New regulation on Advanced Driver Assistance Systems (ADAS)

Proposal for a new Regulation on uniform provisions concerning the approval of motor vehicles with regard to the Blind Spot Information System

Submitted by the expert from Germany*

Figure 1: Dynamic Tests

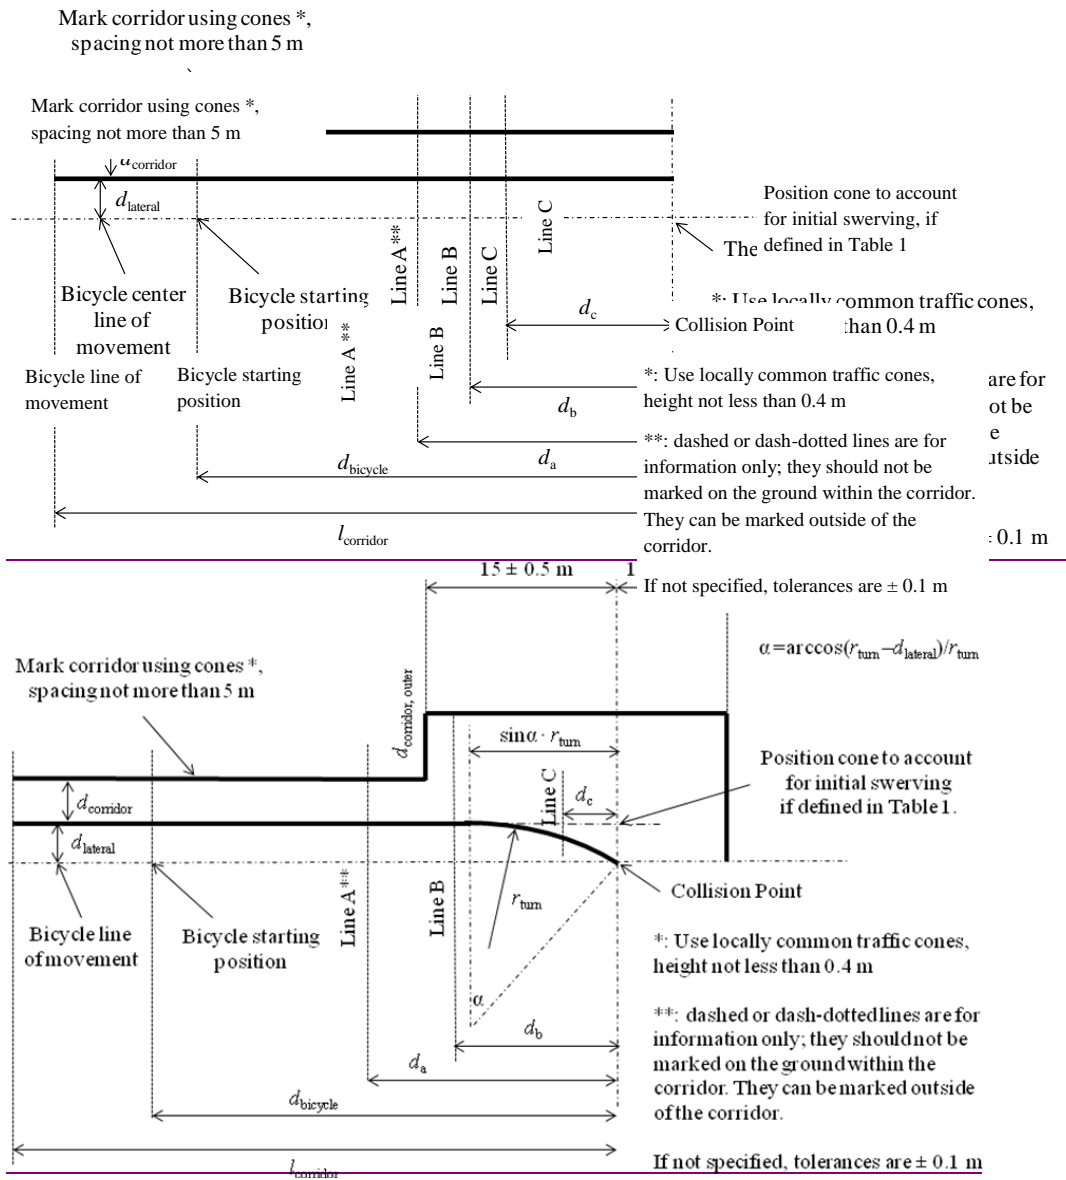
Opmerking [s11]: added to be in line with static test at 6.6.

Opmerking [s12]: Paragraph reworded. All to check if it is OK now.

Opmerking [w13]: Do all tests if turning is deleted (only 7 dynamic + 2 static tests left)

Opmerking [w14]: To be discussed based on general GSR approach. Options see comment to 5.3.1.3. (required speeds). Proposal: P/F criteria is LPI at 15 m line for all cases.

Figure 2: Static Tests

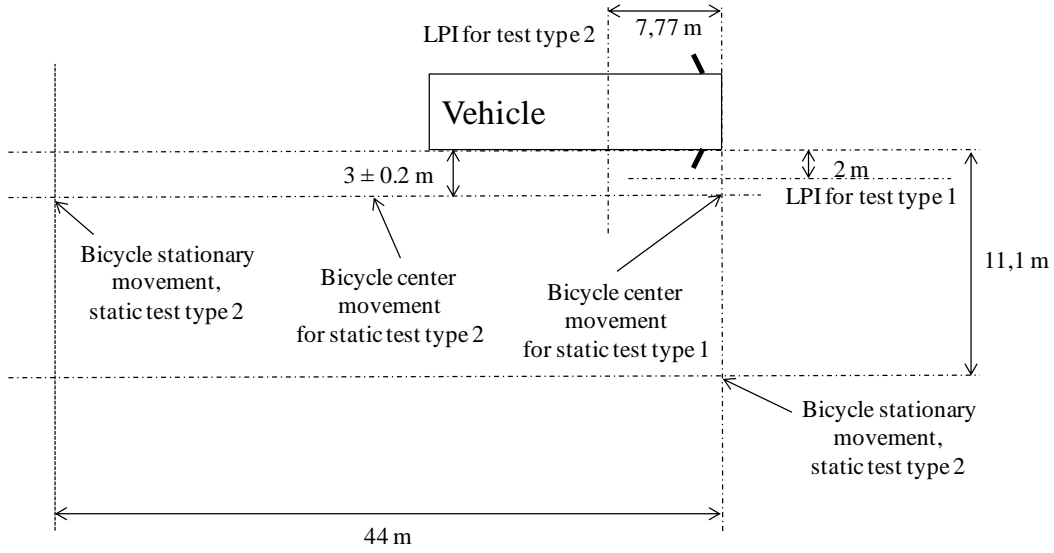
Opmerking [s16]: Background: This test is meant to replicate roundabout situations

Opmerking [s17]: 1.4 s TTC

Opmerking [s18]: No further definition of planes is needed to my understanding: 2 m away refers to the position the bicycle would impact the vehicle on its line of movement.

Opmerking [s19]: Background: This test is meant to replicate situations with a stopped truck due to traffic and fast approaching (additional) bicycles from the rear.

Opmerking [s20]: 8 s TTC

Opmerking [s21]: 1.4s TTC for 20 km/h

Figure 2
Bike target dimensions and dummy posture

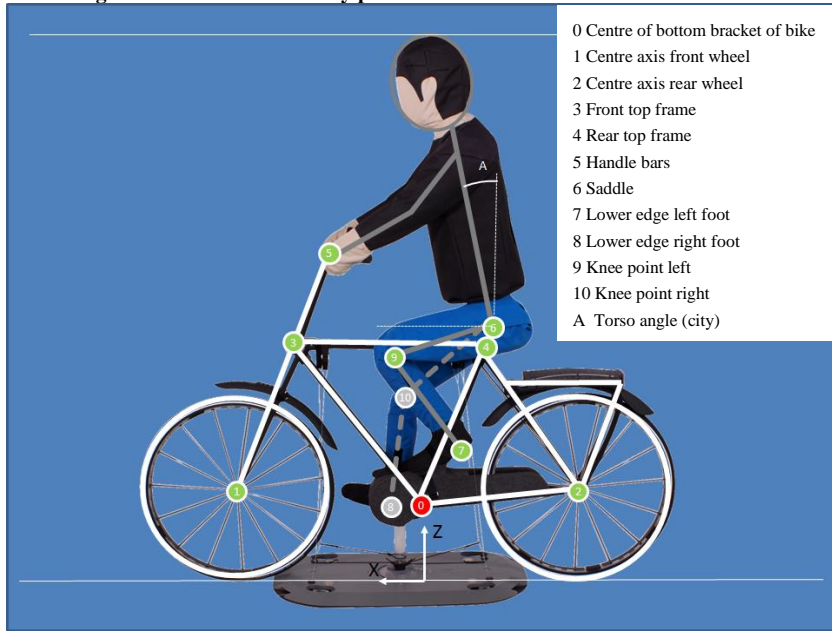
Opmerking [HF28]: Is it possible to be less design restrictive for bicycle target keeping a defined detectability level regarding detection technology used ?

Opmerking [s30]: Discuss about type of bicycle; whether this bike is appropriate.

Opmerking [HF33]: Need to open technology to ultra sonic systems too.

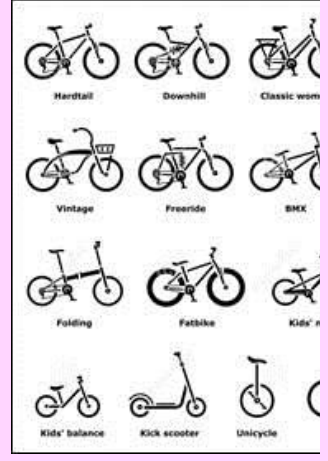
Opmerking [s35]: -§ 2.3. on "bicycle" definition : based on the bicycle-type picture below, a short study brings a saddle + manikin torso height in line with the dimensions in annex 3 for the bicycle target (935+877.cos(10)=1799). Unless there are new discussions on this topic during the 30th meeting, it seems to be consistent.
